## **REMARKS**

### **IN THE DRAWINGS**

Amend the drawings as shown on the attached amended drawings ("Replacement Sheets") pages 1-3 to include the numerals 67, 68 and 78 where indicated.

FIG. 5

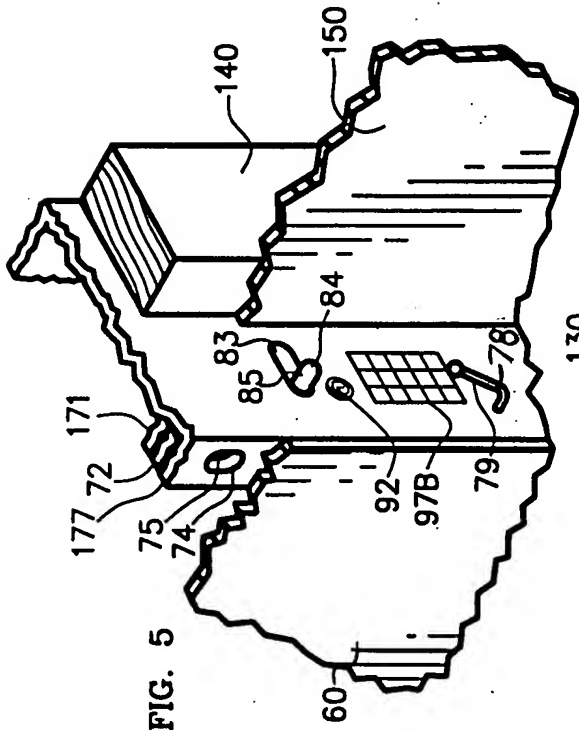
The drawings were objected to as not including the numerals 67 and 78 as mentioned in the Description. The drawings have been amended as shown on the attached amended drawings to include the numeral 67 for "catch means" in Figures 1 and 3 and to include the numeral 78 for "latch plate moving means" in Figures 1, 2, 5, and 6. Figure 3 has been amended to further include the numeral 68 for "catch" added clarity.
